Submission regarding DS22/1032 4 Murdoch Street, Huskisson

On behalf of Keep Jervis Bay Unspoilt

Brief Description of DS: Section 4.55(2) application to modify Development Consent DA10/1377 (as modified) – To make amendments to the external footprints of the buildings, internal configuration changes to both apartment buildings, and increase the unit numbers from 32 dwellings to 38 dwellings comprising eight (8) three-bedroom units and 30 two-bedroom units.

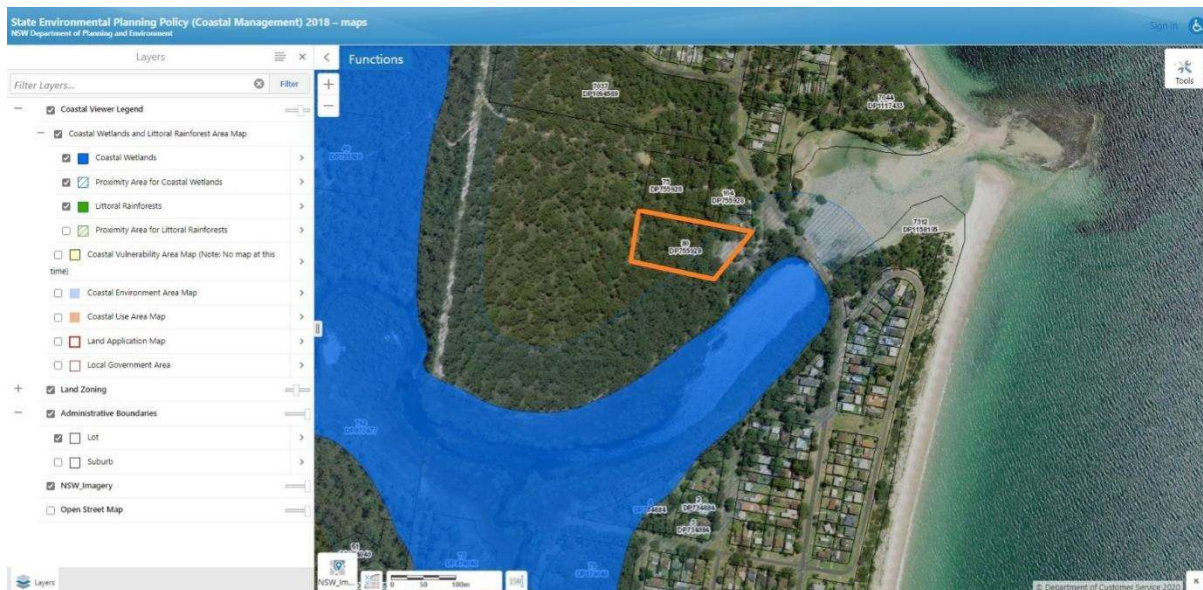
The site is clearly located within the Proximity Area for Coastal Wetlands, as defined by the 'hatched area' in The Coastal Wetlands and Littoral Rainforests Area Map in the Figure below. Whilst the development is not located on the Coastal Wetland Area (marked in solid blue), increased activity during and following habitation of the development has the potential to cause significant damage to this Area.

ii. Coastal Vulnerability Area

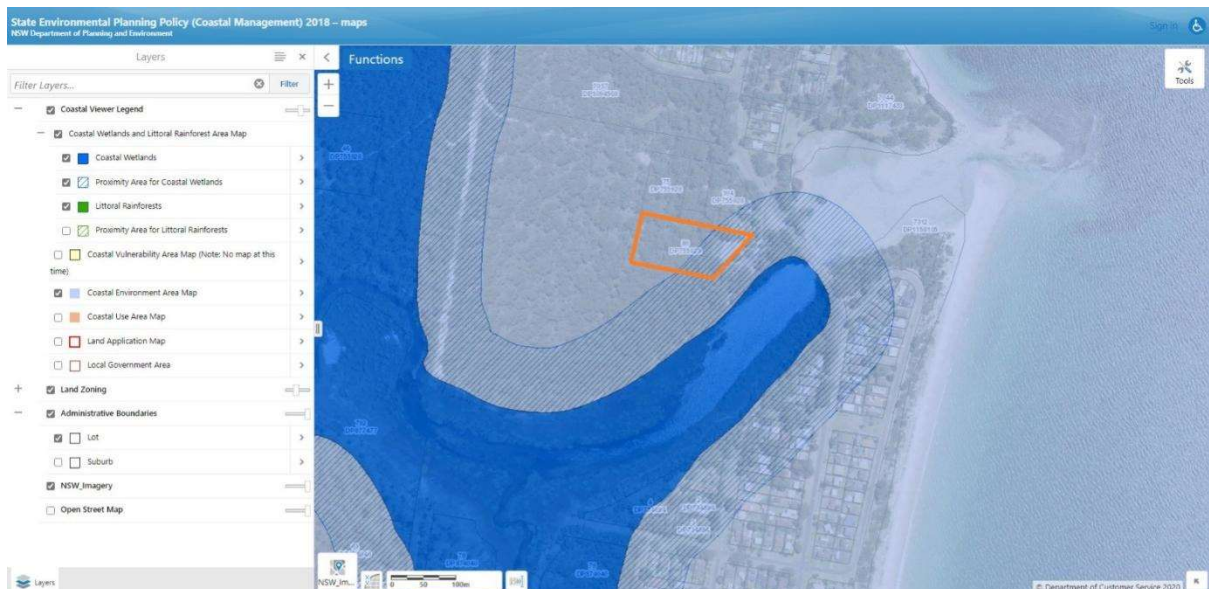
The department mapping tool **has not yet mapped Coastal Vulnerability Areas**. It is an **error** to say that the site 'is not located within the coastal vulnerability area'.

Of great interest, the State Department is promoting that Vulnerable Area mapping exercises can be undertaken by individual Councils where it would be advantageous to do so and have devised a guide to do so. **KJBU requests that the Shoalhaven undertake this exercise and that no further developments or modifications be approved until this mapping has been done.**

Vegetation Management Plan 2020 p. 6

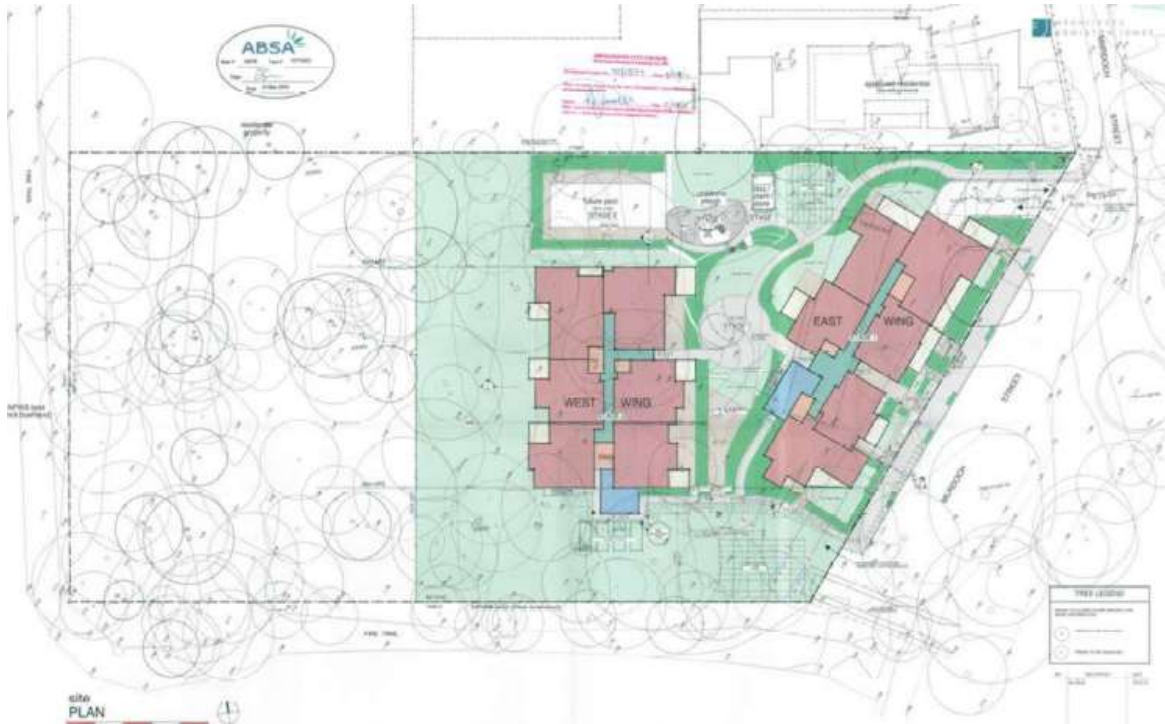
Purdon Planning claims that “the adverse impact in terms of coastal environment area will be minimal and will not be significantly different from the previous design” (pg.13). The argument for the former is that “the footprint of the development has been resolved through consideration and balancing the ecological constraints” as “the building only sits on a portion of the land with the majority of the site to be retained as native vegetation”.

The site plan from the 2020 Vegetation Management Plan indicates that **the majority of the site will be cleared with a portion retained as native vegetation**, but not the majority retained as native vegetation (see Figure below).

KJBU **questions Purdon's interpretation** and argues that "minimal" is not good enough. Indeed, what is the definition of "significantly different"?

4 Murdoch St, 2020 flooding

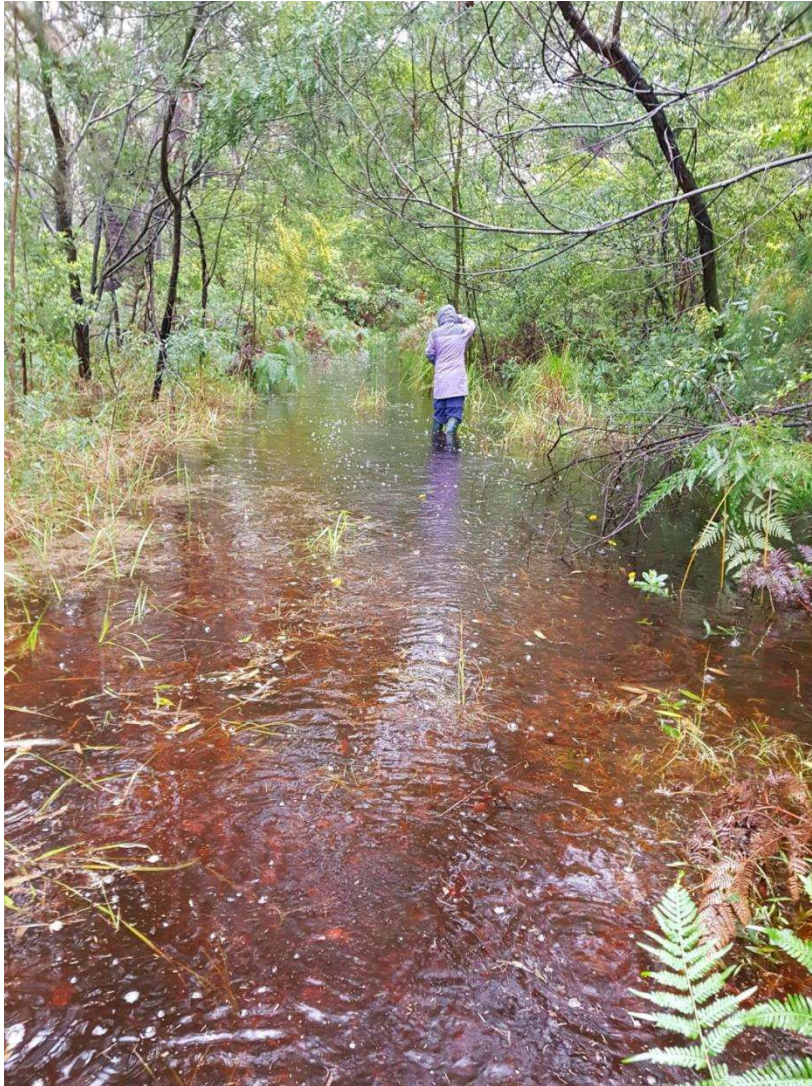
It is reported by Purdon that the site is a flood prone area, and that the site is flood liable. 1% AEP is 2.2m AHD with a flood planning level of 2.7m AHD. This contradicts the Architects ADG response which indicates that the site is not a known flood area.

At the time (8/3/2022) of writing this report the worst ever flooding on record has happened along the entire NSW sea border. River and creek inlets are breaking their banks. Moona Moona Creek is level with its banks. The partially cleared development site of 4 Murdoch St is completely under water and water overflow is running off the block and into the creek. This is the 2nd flood event that has inundated 4 Murdoch Street in the past 2 years. Climate change forecasts predict higher intensity rain events, an occurrence which calls into questions existing flood mapping.
